# A Review of the Limerick Generating Station Severe Accident Risk Assessment

Review of Core-Melt Frequency

Prepared for  
U.S. Nuclear Regulatory  
Commission

Figure 2.1.1 Crust Block source zone used in the LGS-SARA (taken from Appendix A, Figure 5 of LGS-SARA).

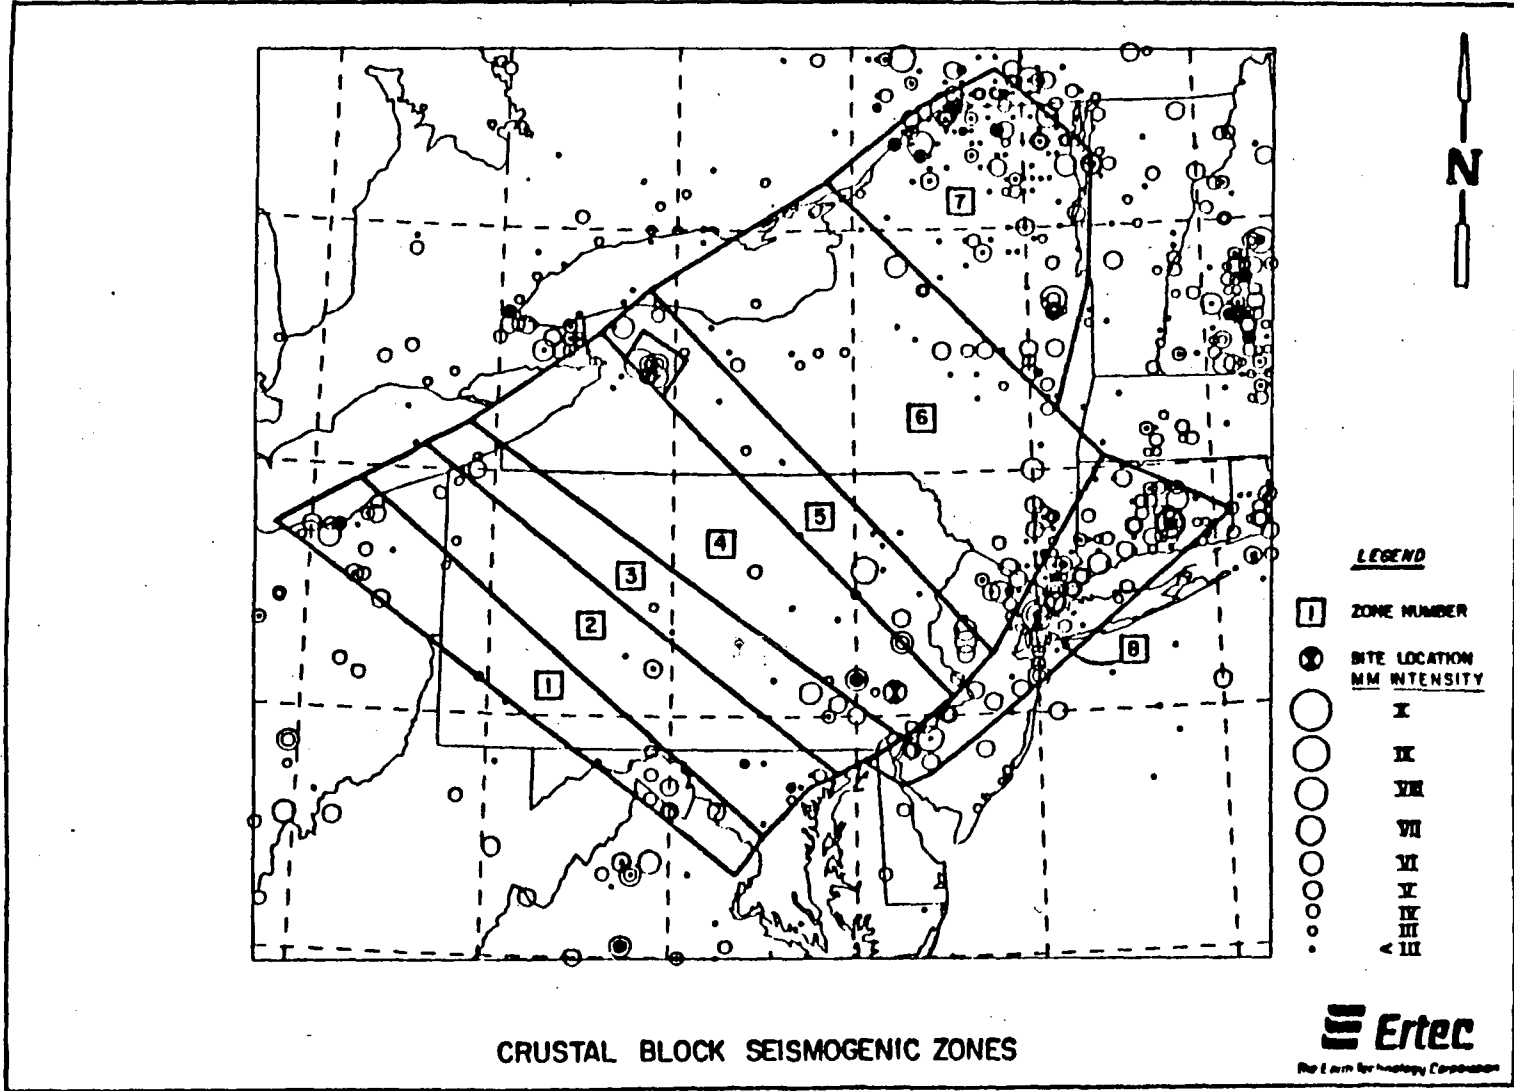
hypothesis (see Figure 2.1). Of these, Zone 8 is the dominant contributor to the hazard at the site. This hypothesis is questioned on two accounts. First, while the principle that large blocks of the earth's crust may control the seismicity in the region along their boundaries is reasonable, such a theory should correlate reasonably well with historic and instrumentally located seismicity. In general, this is not the case (see Figure 2.1).

As stated previously, Zone 8 is reported to have the greatest contribution to the site hazard. A review of Figure 2.1.1 indicates that the closest proximity of Zone 8 to the LGS-SARA site is approximately 30-40 miles. This fact alone explains to a large extent why the hazard curves derived for the Crustal Block hypothesis produced the lowest frequencies. It is further noted in Figure 2.1.1, which also shows the distribution of seismicity to 1980, that the northwest boundary of Zone 8 appears to be inconsistent with the pattern of earthquake occurrences in southern New York, New Jersey, and eastern Pennsylvania. At the meeting at SMA, it was learned that Zone 8 was modeled to represent the Triassic Basin. The inconsistent delineation of Zone 8, with respect to local seismicity patterns, may be attributed to two factors. The LGS-FSAR<sup>(6)</sup> reports that Limerick is in the Triassic Lowlands, suggesting that the northwest boundary of Zone 8 should be moved toward the plant. This would also be consistent with the distribution of seismic events in the region (see Figure 2.1.1).

A redefinition of Zone 8 in the Crustal Block hypothesis that places the LGS site within its boundaries is judged to have a moderate impact on the estimated hazard curves (i.e., at least a factor of 2). The consequences of this change on the mean frequency of core melt is estimated to be small (i.e., a factor of 2 or less). However, a moderate increase in the median core melt frequency is considered possible.

Figure 2.1.2 Comparison of various historical seismicity curves and the LGS-SARA seismicity curves from Appendix A for sustained-based peak acceleration for the Decollement and Crustal Block,  $M=5.5$  seismogenic zones.

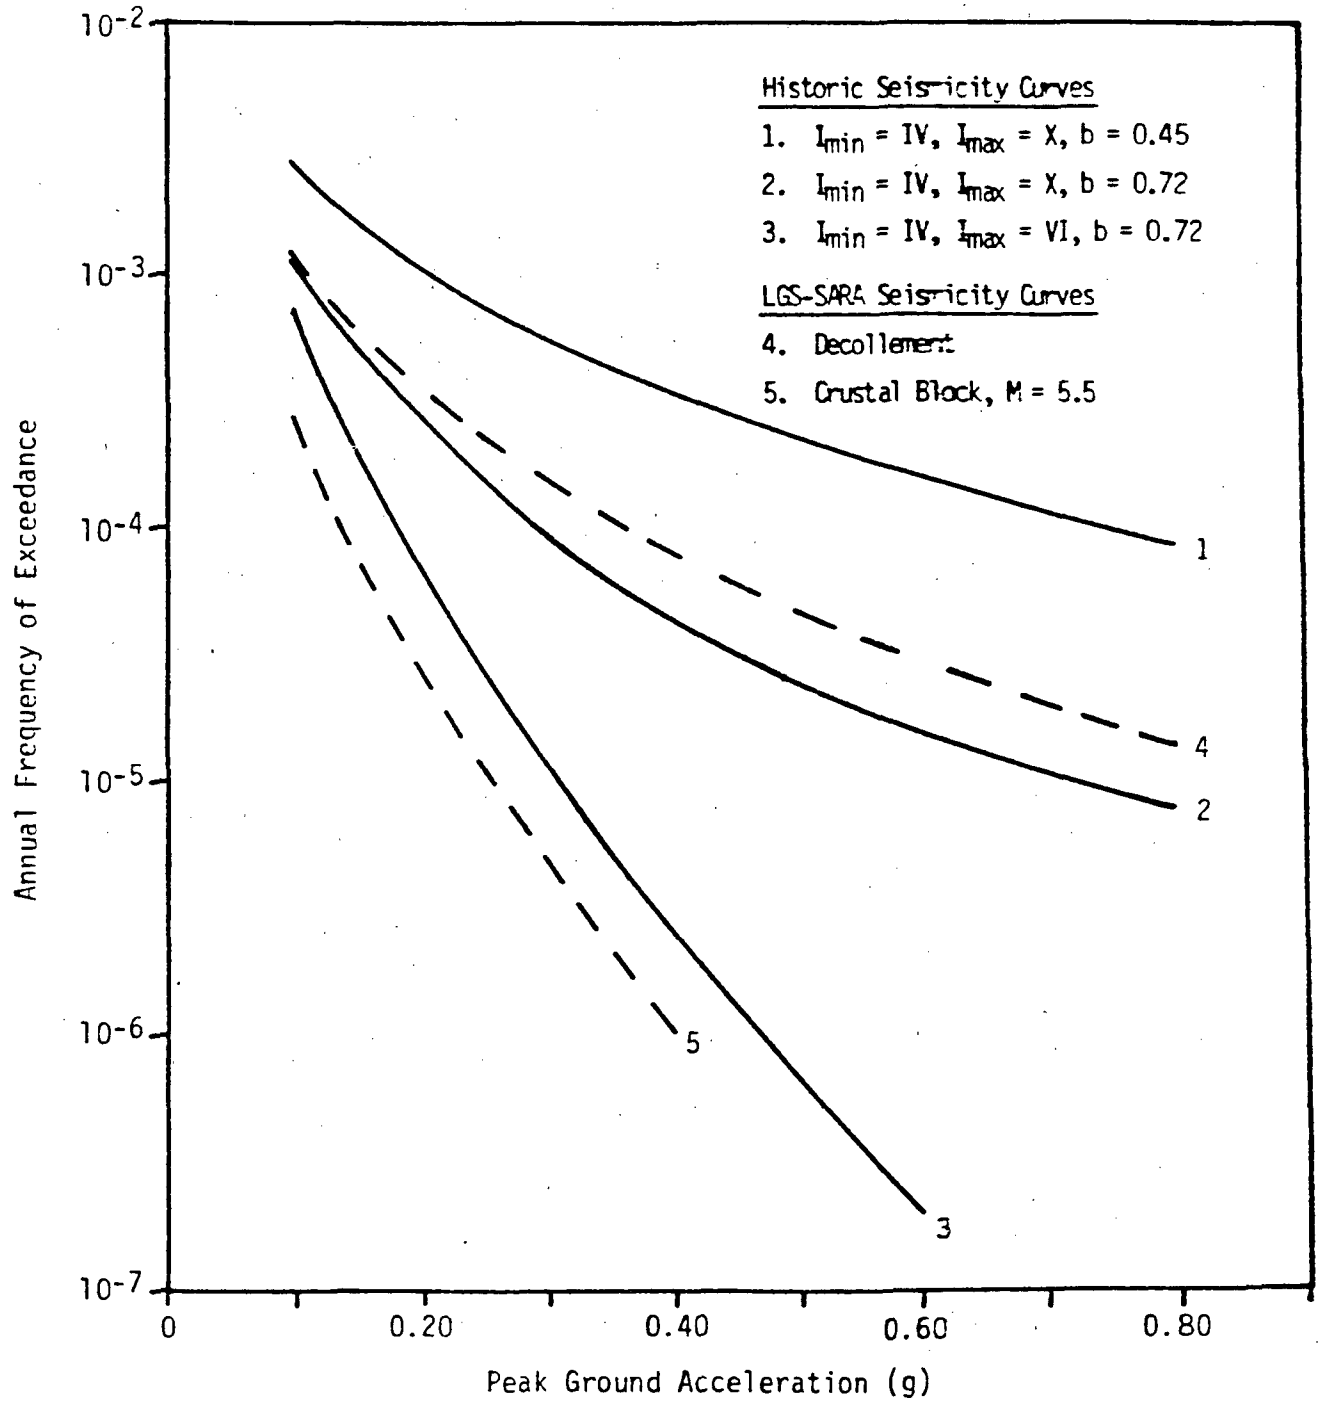
The result of this computation, using  $I_{max}$  of VI, is shown in Figure 2.1.2 with selected curves from the LGS hazard analysis. The historic seismicity curve compares to accelerations around 0.10g from the results obtained from the Decollement and Piedmont zones to the lower frequencies estimated by the Crustal Block zone. These observations suggest that the overall frequency of events producing accelerations of 0.10g is reasonably well described by the Decollement and Piedmont zones and the Crustal Block zone,  $M=6.0$ , to within a factor of 2. Since the assumed maximum intensity felt at the site is MMI VI, the historic frequency curve falls off sharply.

the same step that was taken in the probabilistic seismic hazard analysis. A maximum intensity of  $X$  was assumed, which corresponds to a large-magnitude ( $\approx M7.0$ ) event occurring very near the site. The result of estimating  $f(I)$  in equation 2.4 and calculating  $\nu(A>a)$  for a maximum intensity of  $X$ , is also shown in Figure 2.1.2. This assumption allows the possibility of high accelerations associated with large events to occur. In general, the site intensity curve tracks the trend of the Piedmont and Decollement seismicity curves quite well.

As a final estimate based on the historic distribution of ground motion at the LGS, a seismicity curve is estimated assuming a Richter  $b$ -value of 0.45 which corresponds to the 0.90 value used for earthquake magnitude in the LGS-SARA. Again, a maximum intensity  $MMI X$  is assumed. The hazard curve for this case is shown in Figure 2.2. The effect of assuming a  $b$ -value of 0.45 (equivalent to 0.90 for the magnitude scale) results in a factor of four increase in the hazard.

Figure 3.1.2 Reduced fault tree for failure to scram.

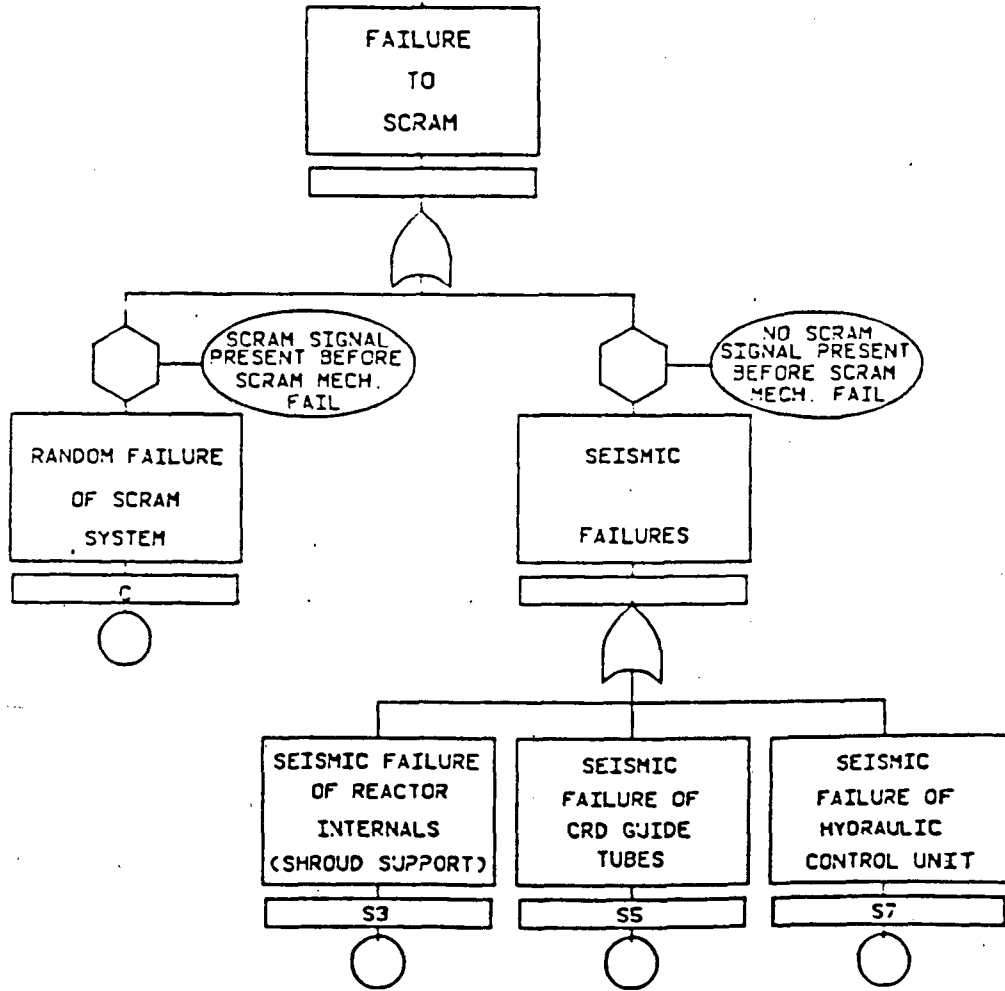
A telephone conversation with PECO revealed that the  $PC_R$  is a judgmental factor applied to the seismic failure of the reactor internals and CRD guide tubes (see Figure 3.1.2). PECO stated that failure of the CRD guide tubes or the reactor internals due to an earthquake would cause a failure to scram only 20 % of the time. Since information on how this  $PC_R$  value is obtained is incomplete, it is difficult for BNL to judge its validity.

Figure 3.1.5 Seismic event tree for loss of offsite power without scram.

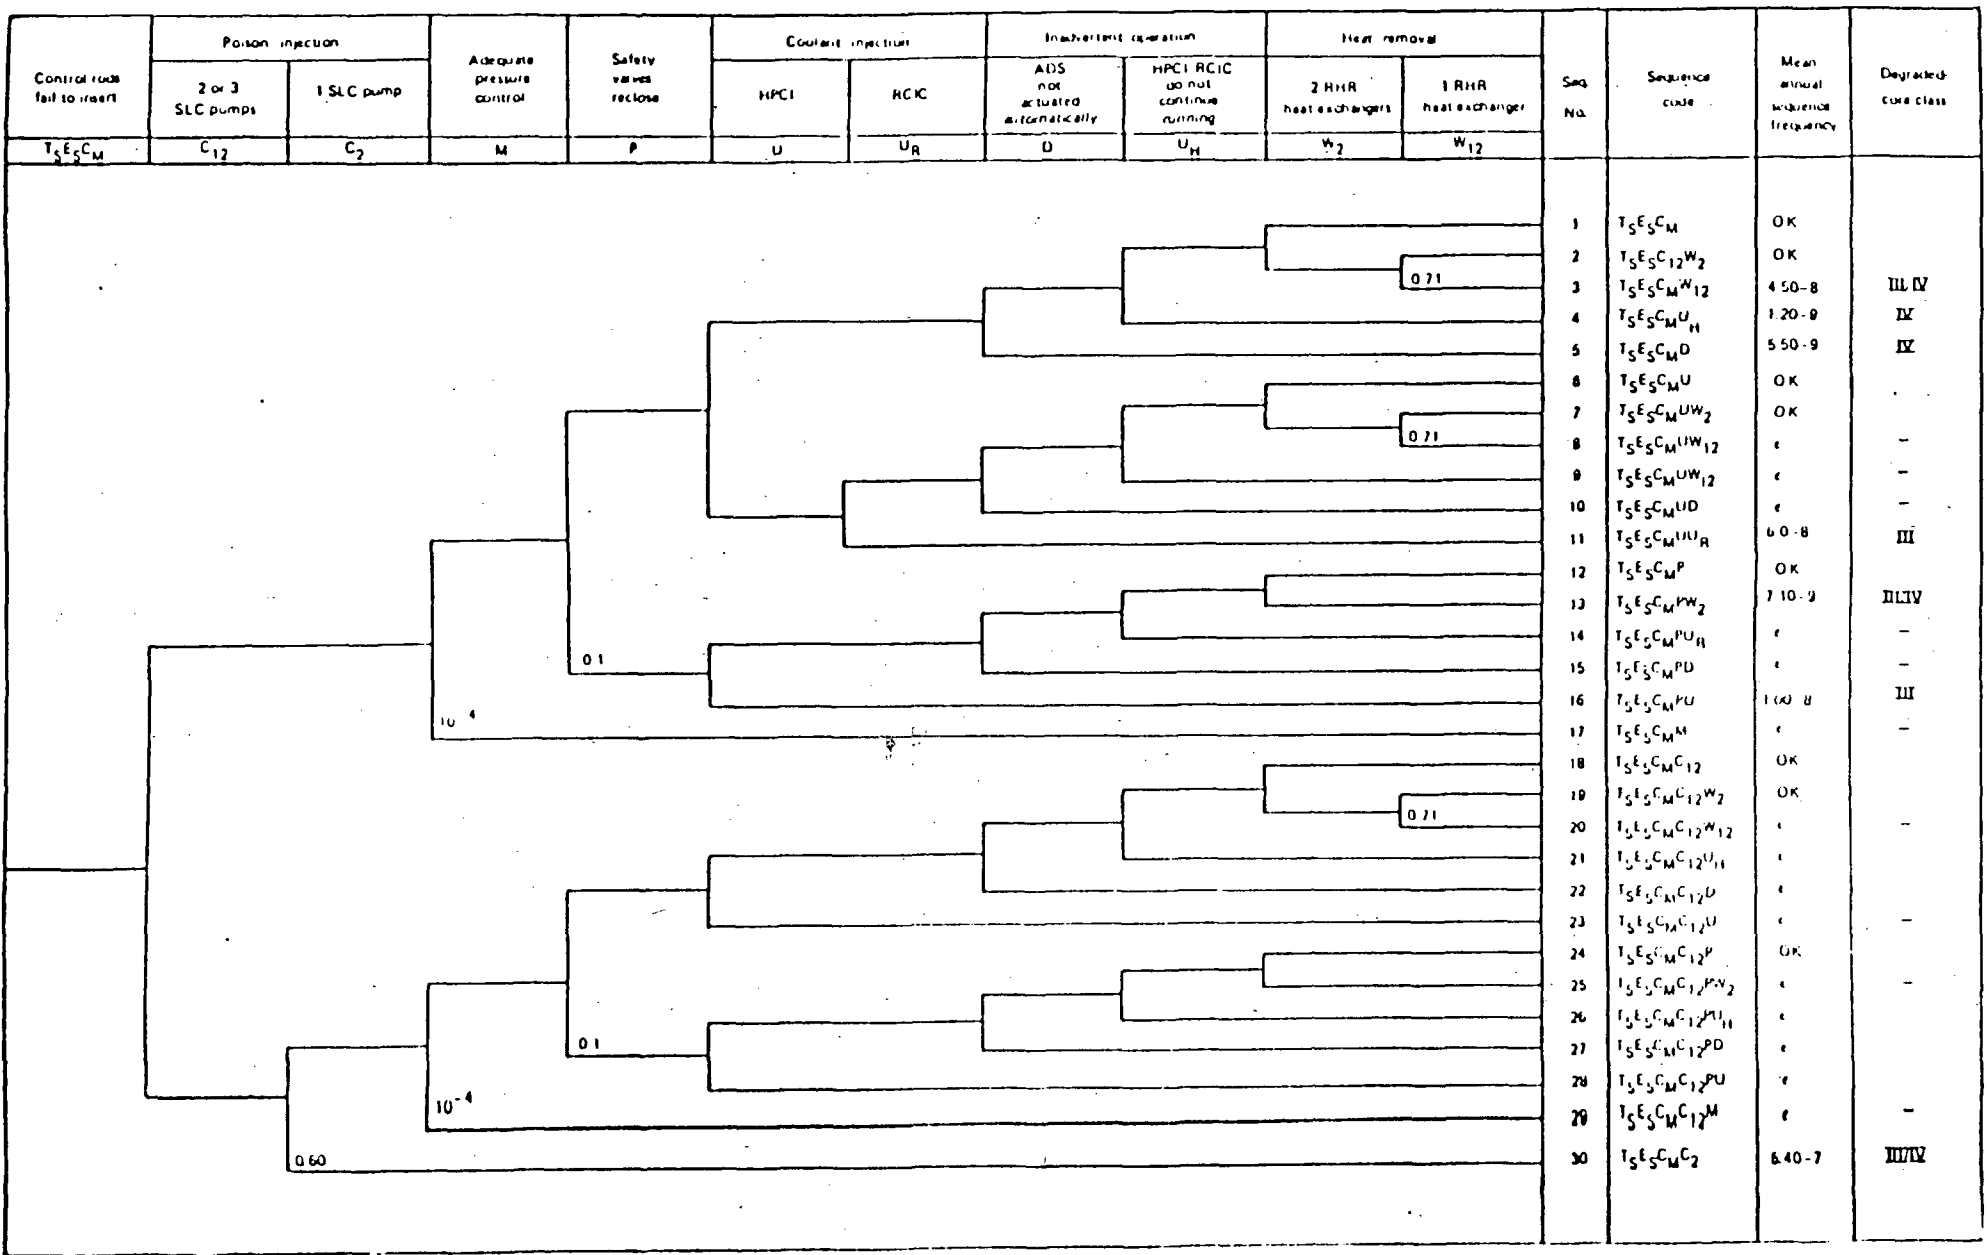
If, in the reactor transient, there is a failure to scram, an event tree similar to Figure 3.1.5 should be developed. It is conceivable that the contribution to risk due to Class V sequences may not be negligible. It is recommended that these considerations of additional accident sequences should be addressed in the LGS-SARA.

BNL reviewed the LGS-SARA ATWS event tree and found that, in addition to those two dominant ATWS sequences,  $T_S E_S C_M C_2$  and  $T_S R_B C_M$ , the contribution to core damage from other ATWS sequences defined in Figure 3.1.5 is relatively small. However, with the BNL definition of  $C_M$ , there will be about a factor of 5 increase for all the ATWS sequences in Figure 3.1.5. The total ATWS core-damage frequency reported in LGS-SARA is  $8.1 \times 10^{-7}$ ; by eliminating the PCR and using the BNL  $C_M$  definition, the total ATWS core damage becomes approximately  $4.0 \times 10^{-6}$ . This does indicate that the ATWS results are quite sensitive to the parameters used to define the failure of scram. PECO believed that it is conservative in assuming that those failure modes defined for the reactor internals and the CRD guide tubes will directly cause a failure to scram. BNL tends to agree that the definition of failure modes of these components may be conservative and would encourage additional analysis to support the LGS-SARA assumptions. A refined analysis in this area is needed since it will have significant impact on the acute and latent fatalities.
